AUDI OF NOVI JSP21-34

Consideration of the Revised Final Site Plan at the request of Lithia Motors, Inc. The subject property is approximately 3.91 acres and is located at the northwest corner of Ten Mile Road and Haggerty Road in the B-3, General Business Zoning District. The applicant is proposing to repurpose the approximately 19,000 square foot former Jaguar Car Dealership building for Audi of Novi, along with associated parking, vehicle inventory, and site improvements.

PLAN REVIEW CENTER REPORT

Review Date: June 26, 2023
Review Type: Revised Final Site Plan (*New Layout*)
Project Name: **JSP 21-34 Audi of Novi**
Plan Date: June 6, 2023
Prepared by: Ben Peacock
Contact: E-mail: bpeacock@cityofnovi.org Phone: (248) 347-0579

**ARCHITECTURAL
SITE PLAN**
SCALE: 1" = 30'-0"

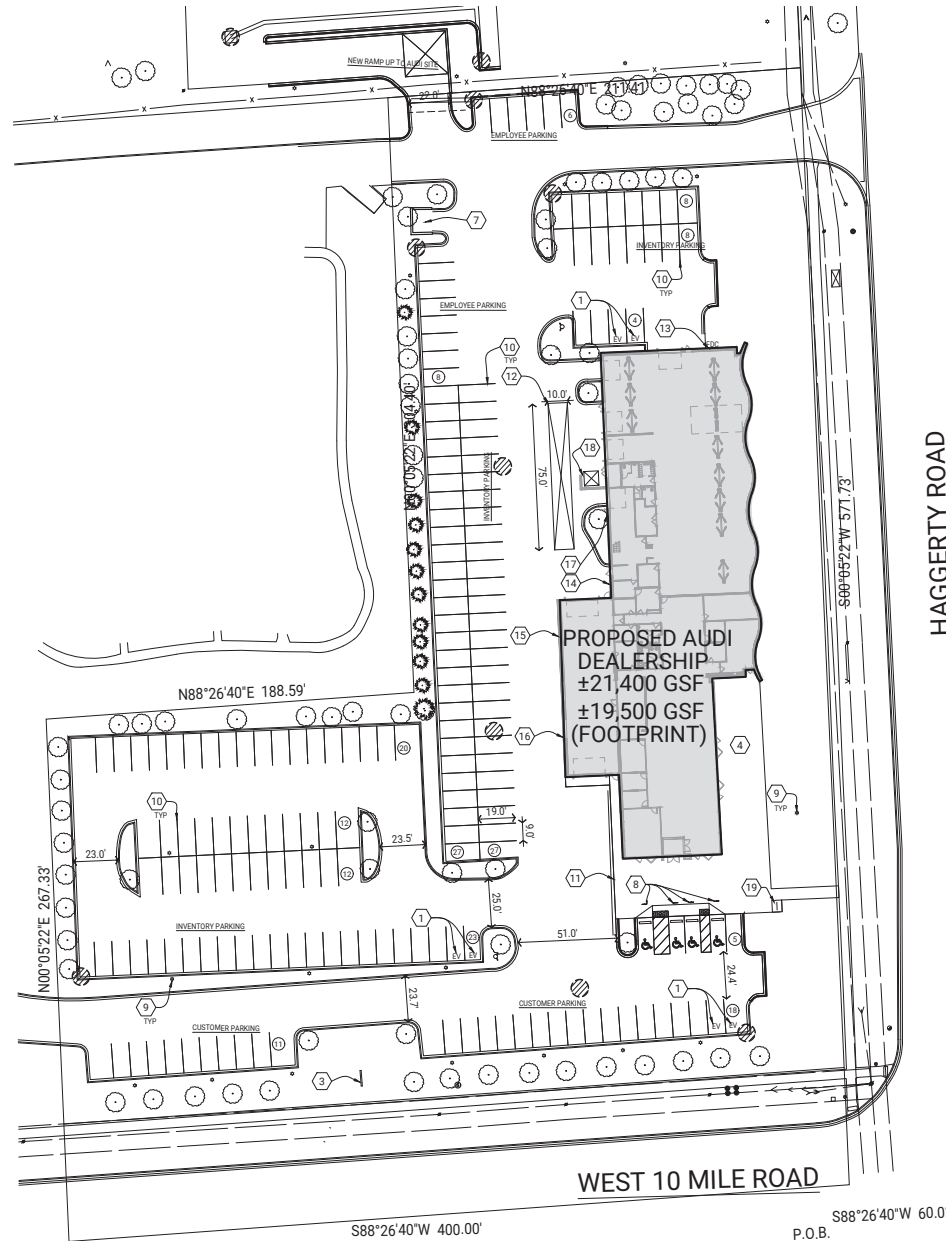
3. Parking Space Setbacks (Sec. 3.1.12.D): The non-compliant existing north yard setback of 1.15 feet is proposed to be increased to 1.75 feet (still not in compliance). **The applicant will seek a new waiver from the Planning Commission for the north yard parking setback. Please confirm that the curb is truly being removed and replaced less than a foot away and provide reasoning for doing so in your response letter.**

Building Setbacks (Sec 3.1.12.D)				
Front (south)	30 ft.	approx. 124 ft.	Yes	
Exterior Side (east)	30 ft. * see 3.6.2.C	33.3 ft	Yes	
Interior Side (west)	15 ft.	76.49 ft	Yes	
Rear (north)	20 ft.	137.97 ft	Yes	
Parking Setback (Sec 3.1.12.D)				
Front (south)	20 ft.	20 ft.	Yes	The applicant will seek a new waiver from the Planning Commission for the north yard parking setback.
Exterior Side (east)	20 ft. (see 3.6.2.C)	37.84 ft	Yes	
Interior Side (west)	10 ft.	10.7 ft	Yes	
Rear (north)	10 ft.	1.75 ft Applicant indicated in their response letter that the existing 1.15-foot parking setback will be increased to 1.75 feet.	No	Please confirm that the curb is truly being removed and replaced less than a foot away and provide reasoning for doing so in your response letter.

- b. Parking Setback Waiver of 8.25 feet (10 feet required, 1.75 feet proposed) along the north property line *since the existing setback deficiency is not being expanded (and is technically being reduced), which is hereby granted;*

FACADE ELEVATIONS AND RENDERINGS

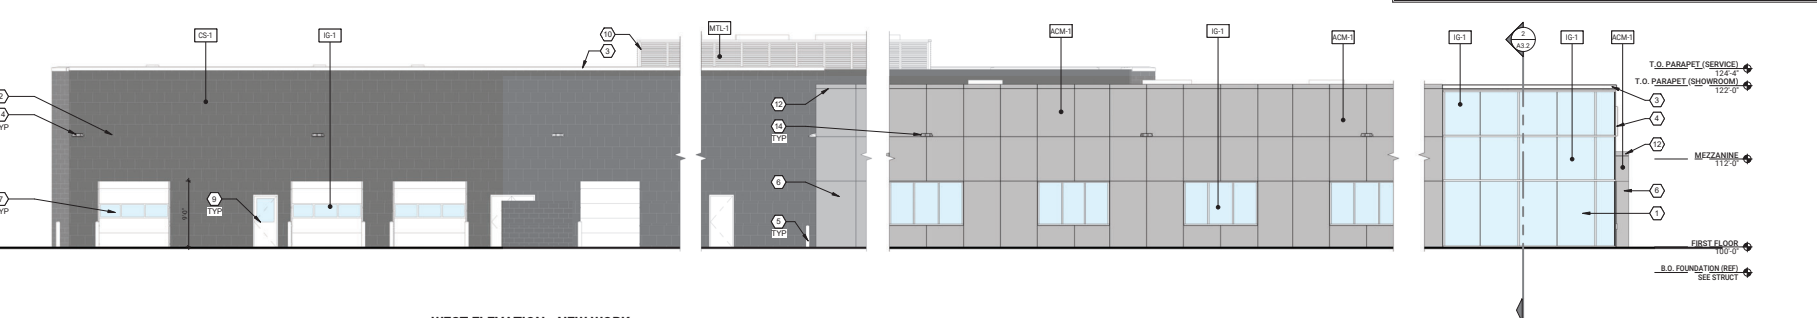
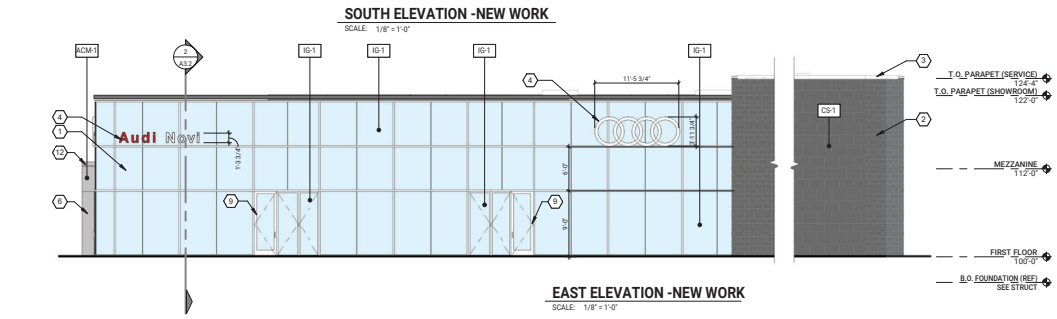
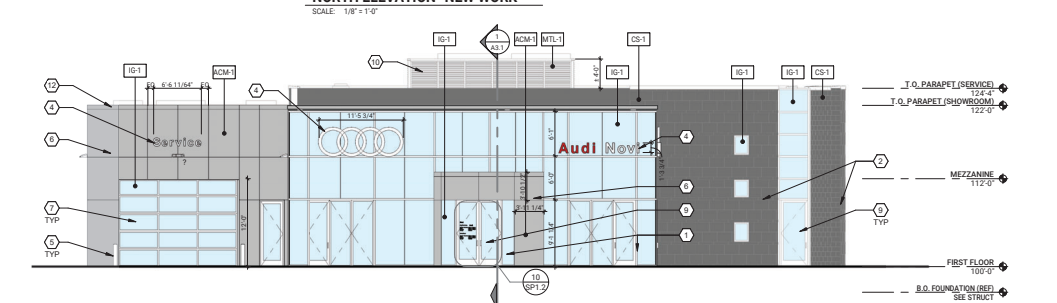
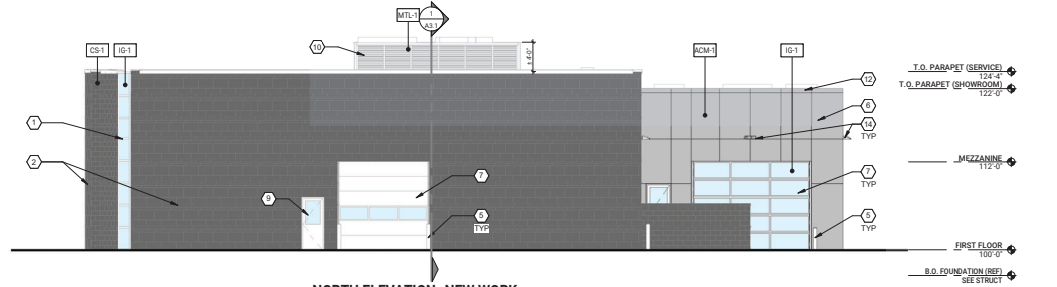
2. Overhead doors (Sec. 3.10.3.A) No truck well, loading dock, overhead door or other type of service bay door shall face a major thoroughfare, nor an abutting residential district. **Although the south facing overhead door is existing, it will be structurally modified, so the applicant will seek a new ZBA variance from this standard.**

B-3 Business District Required Conditions (Sec. 3.10.3)				
Truck Well and Overhead Doors (Sec. 3.10.3.A)	No truck well, loading dock, overhead door or other type of service bay door shall face a major thoroughfare, nor an abutting residential district. Pedestrian exits or emergency doors are permitted on such building facades.	The overhead door on the south elevation faces a Major Thoroughfare (Ten Mile Road). The north overhead doors do not.	No	Since the overhead door on the south elevation will be structurally modified, the applicant will seek a new ZBA variance from this standard.

- a. Zoning Board of Appeals Variance from Section 3.10.3.A of the Zoning Ordinance for an overhead door on the south elevation of the building facing a major thoroughfare (Ten Mile Road) as recommended by staff *because it is partially an existing condition of the building, but structural modifications are proposed. In addition, the previous variance granted for two overhead doors on the original site plan layout has expired;*
